ADDENDUM NO. 2

RUNWAY 17-35 REHABILITATION

STATE PROJECT NO. AH2021-16

December 4, 2023

PHASING AND BARRICADE PLAN OVERVIEW

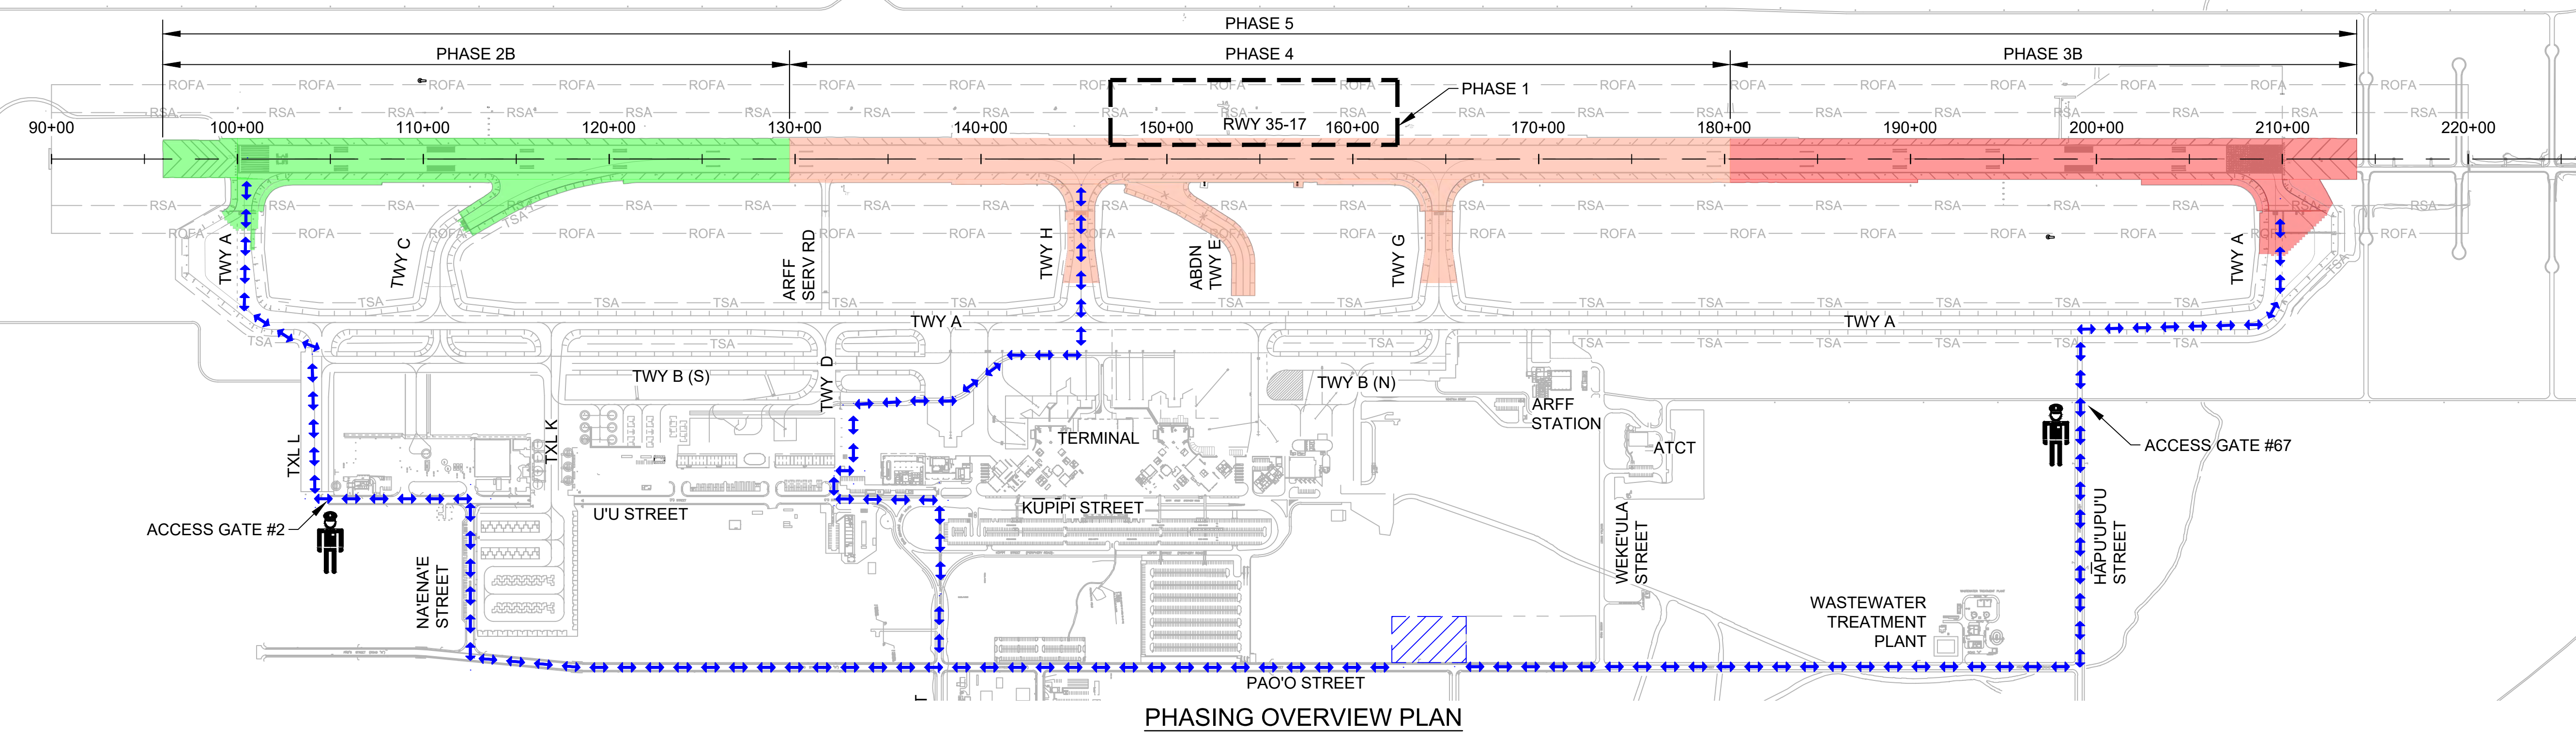
41. 18. Also, Plan Sheet G-123 indicates 78 calendar days but plan sheet G-101 indicates 71 calendar days? Also, please clarify the two (2) work periods indicated 0000-0600 (HST), 1000-1600 (UTC) --- assuming this is the same period of 6 hours, with two (2) time zone standards referenced?

HDOT Response: The duration of Phase 5 shall be 78 days. Updated Dwg G-101 is included in this addendum.

PAVING LAYOUT PLAN 1

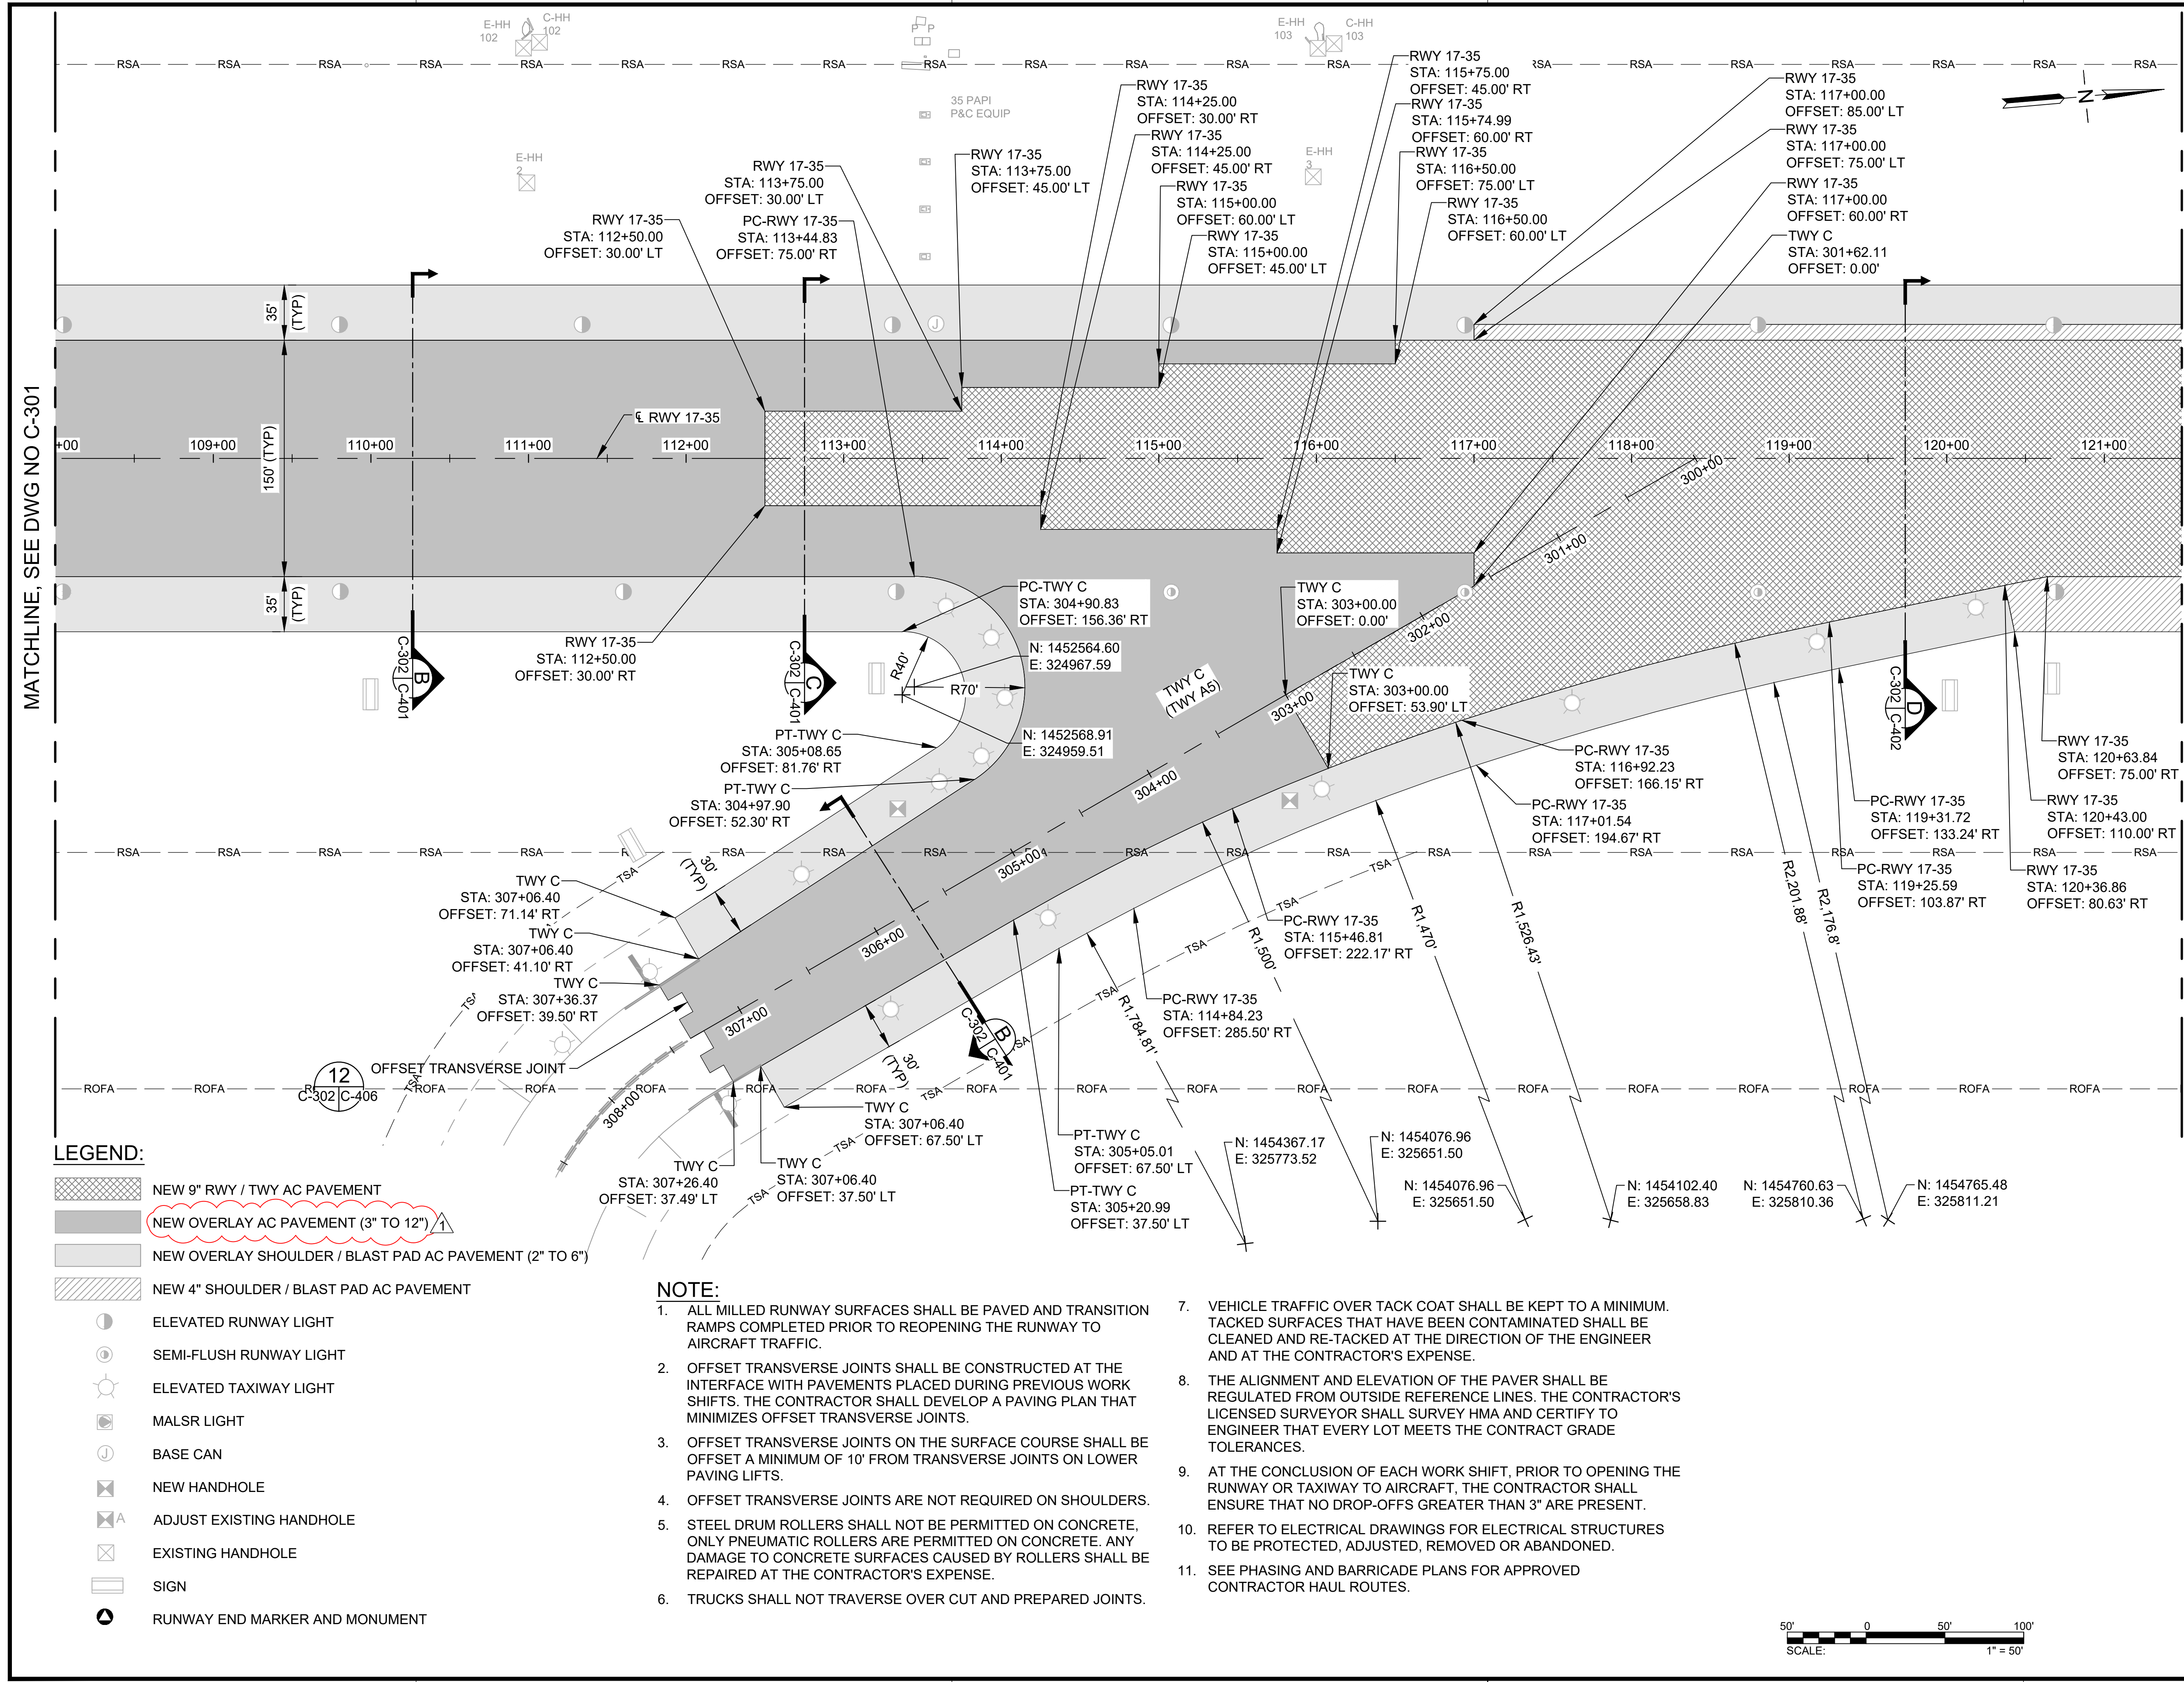
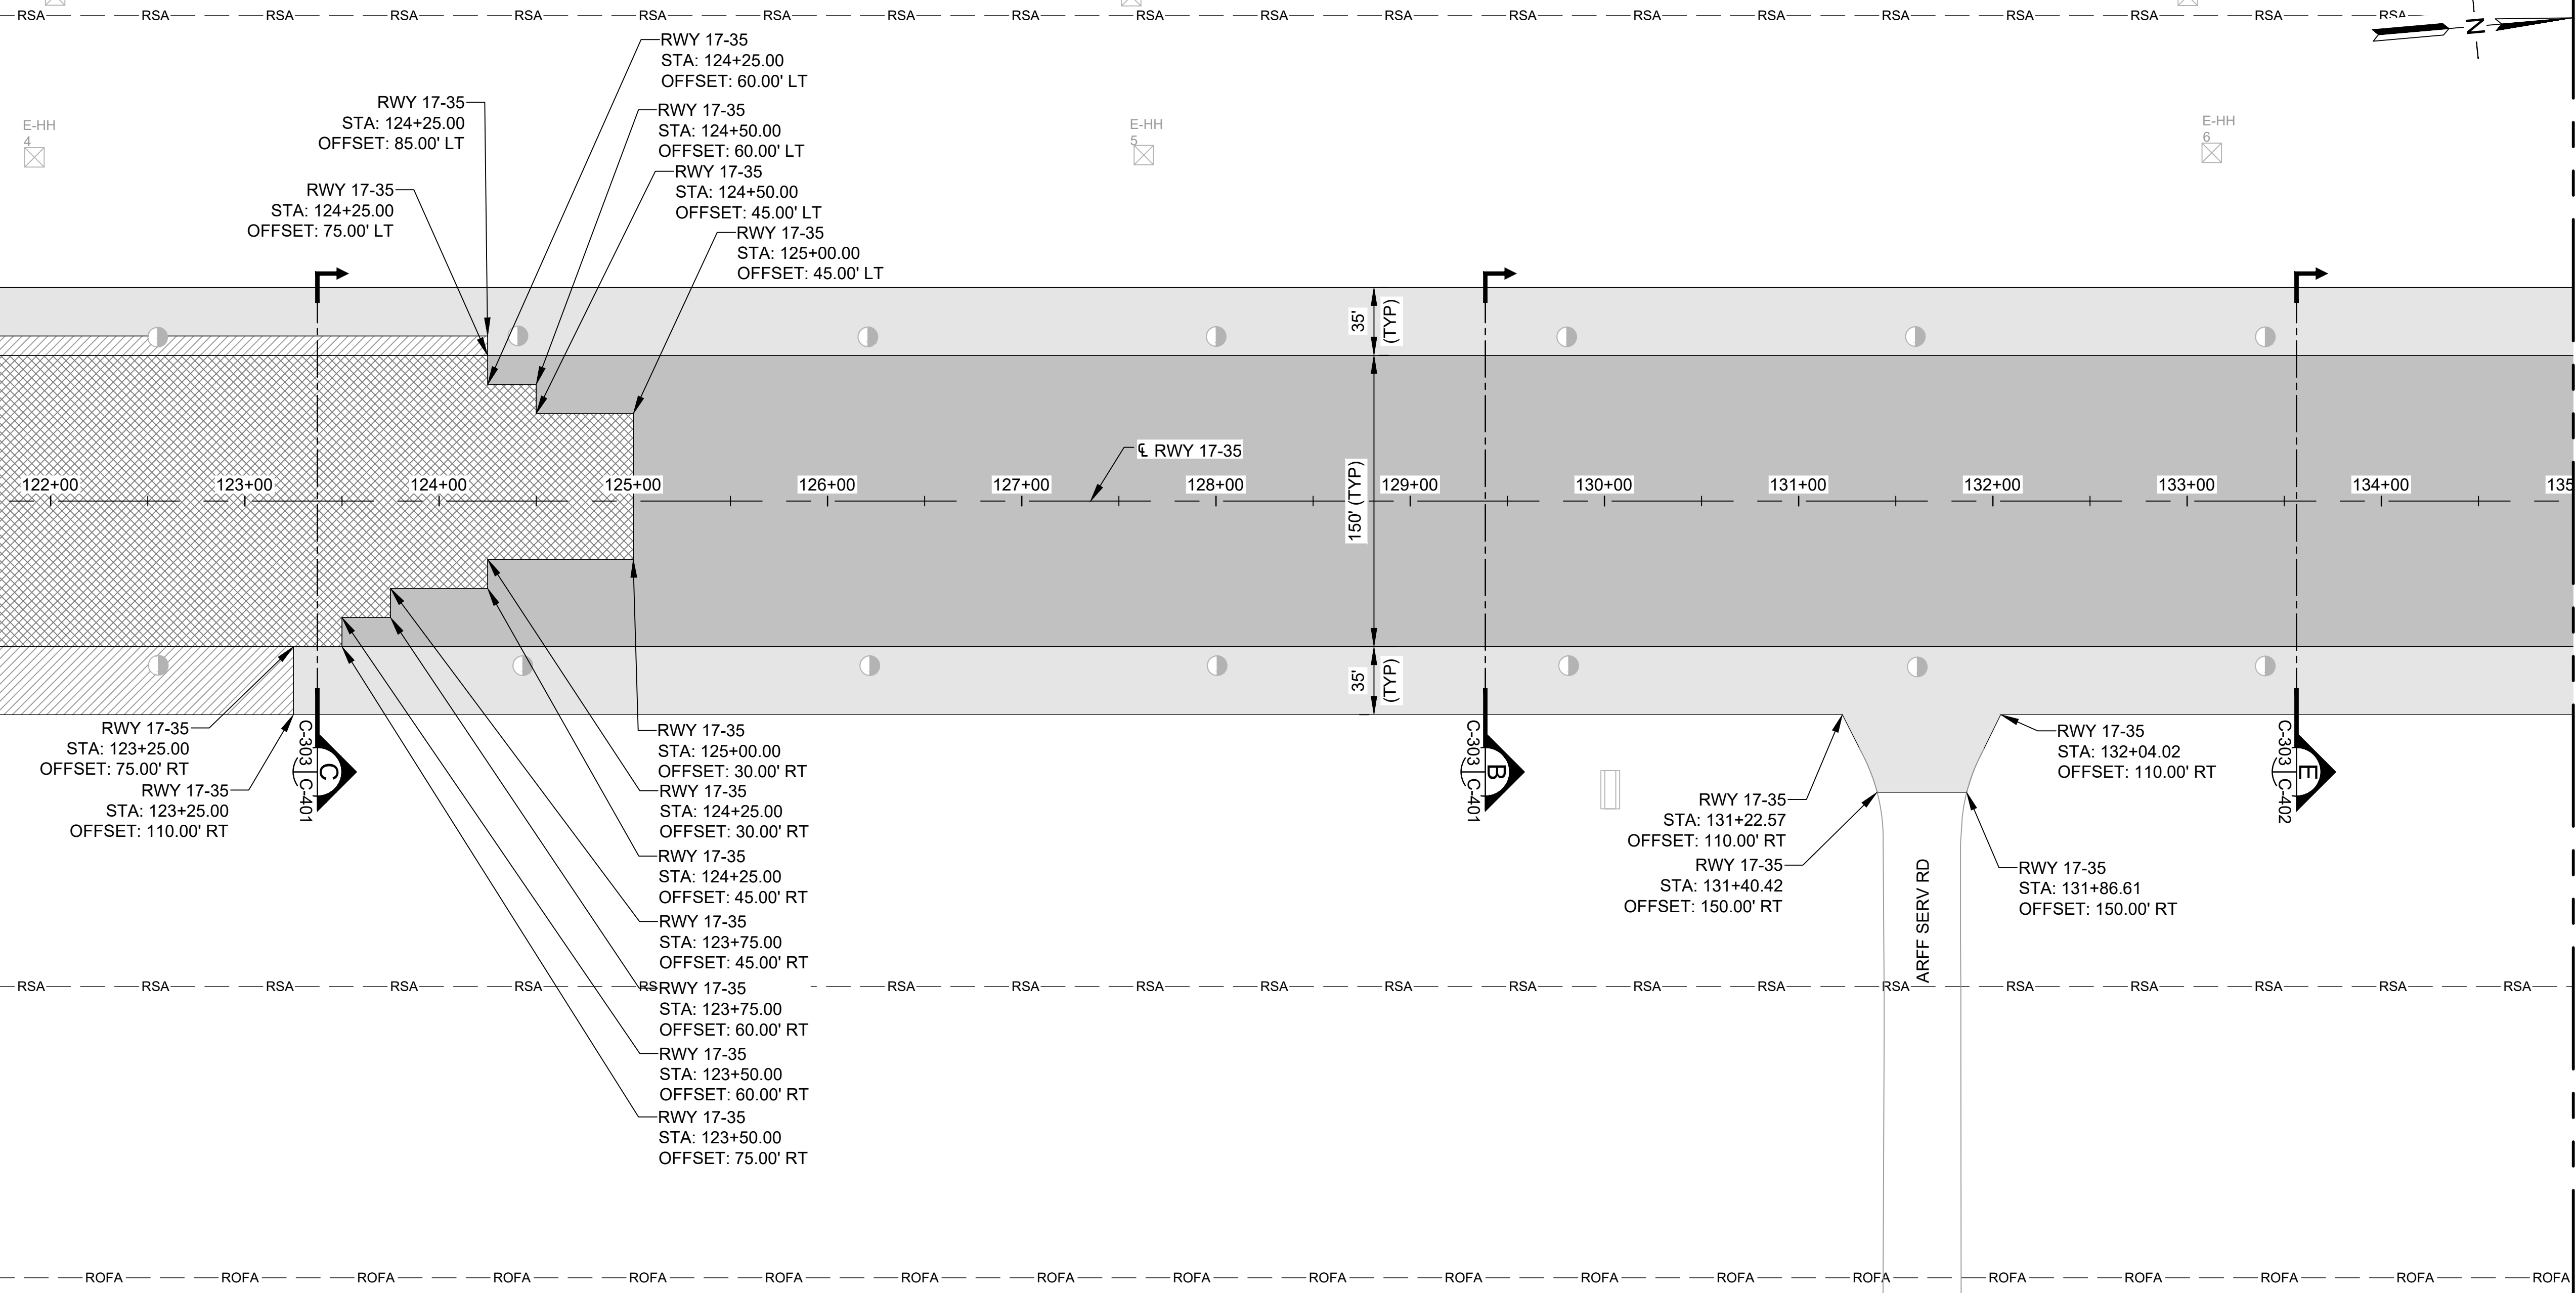
4. For example, detail B/C-401 calls out "3 inch to 6 inch a.c. pavement surface course" for the runway, but the hatching on Drawing C-301 indicates "new overlay a.c. pavement 3 inch to 9.5 inch" for the same location. Please clarify if 6" a.c. surface course is the maximum thickness required for this section of the runway. Please clarify if the details on Drawing C-401 to C-404 indicates the maximum thickness of a.c. for each runway/taxiway/blast pad section.

HDOT Response: Dwgs C-301 through C-309 differentiate the areas of runway/taxiway reconstruction, shoulder reconstruction, runway/taxiway overlay, and shoulder overlay. Dwgs C-401 through C-404 provide more detailed pavement section information for the approximate station ranges shown on each detail. Dwgs C-301 through C-309 have been revised to show New Overlay AC Pavement (3-in to 12-in). Revised drawings are included in this addendum.
